# Peer Review of Glen Eira's Draft Quality Design Guidelines and Strategic and Urban Renewal Development Plans Analysis

Client: Glen Eira City Council

**AECOM Australia Pty Ltd**

17-Oct-2017

**Figure 19 Aerial view (looking south-west to north-east) of strategic site envelopes for Bentleigh Activity Centre**

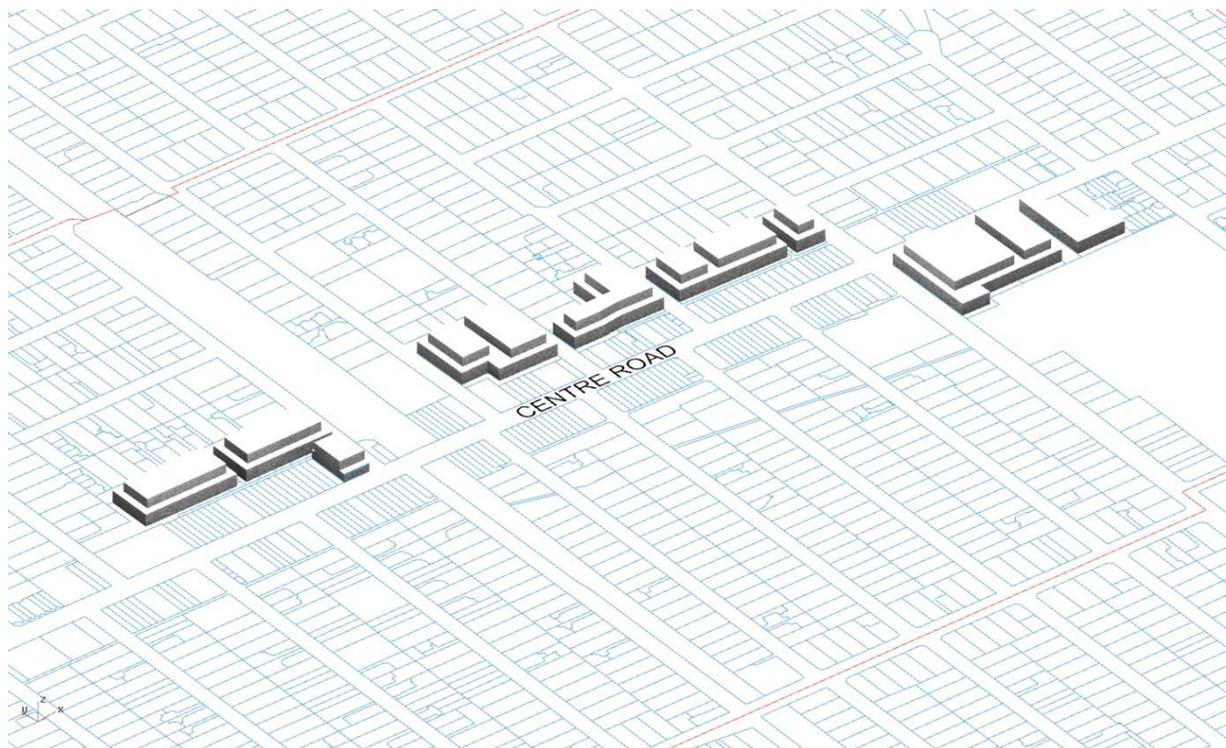
Figure 19 illustrates the regularly shaped Strategic Sites in Bentleigh generally interfacing with the rear of existing shops along Centre Road (generally to the south) and residential areas (indicated for Garden Apartment or Terrace Townhouse types of development) generally across the street to the north of most of these sites. Interfaces with adjacent streets and lanes, and the scale of proposed development types beyond will be easily integrated with the proposed Strategic Site type of development on these sites.

**Figure 20 Aerial view (looking south-east to north-west) of strategic site and urban renewal area envelopes for Carnegie Activity Centre – showing midday shadows at September 22**

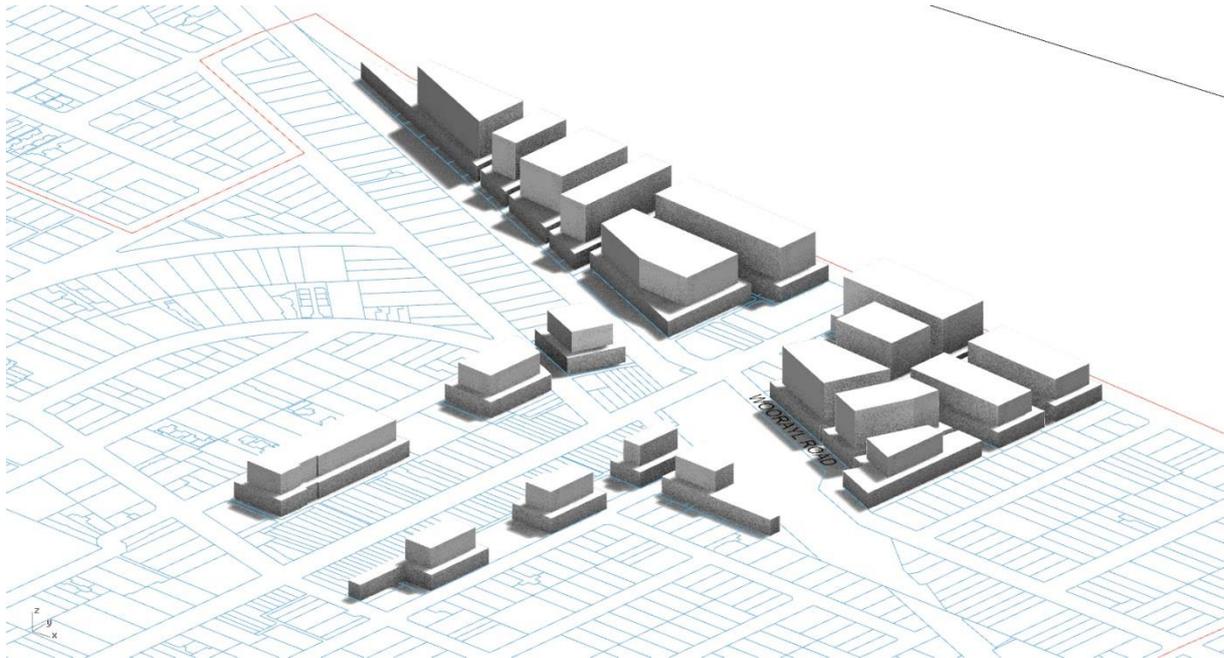
- Overshadowing impacts to Woorayl Street Park would likely to substantially decrease the overall height and development yield of sites between Woorayl Street and Arawatta Street (to 5-6 storeys) if June 22 shadows are adopted in Guidelines, while September 22 shadows are more easily reconciled with the maximum height (with community benefits) as shown in Figure 20. This model has assumed an adoption of September 22 shadow

**Figure 21 Aerial view (looking south-east to north-west) of strategic site and urban renewal area envelopes for Elsternwick Activity Centre – showing midday shadows at September 22**

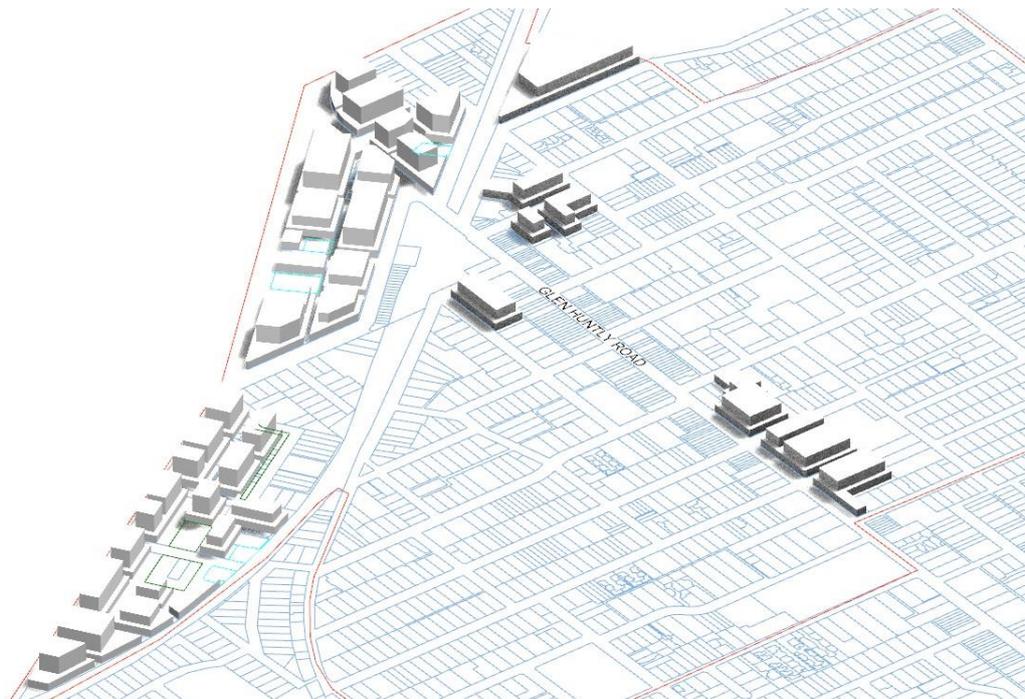
- Overshadowing impacts to new public open spaces would likely to substantially decrease the overall height and development yield of sites to the north, east and west of the new public open spaces if June 22 shadows are adopted in Guidelines, while September 22 shadows are more easily reconciled with the maximum height (with community benefits) as shown in Figure 20. This model has assumed an adoption of September 22 shadow
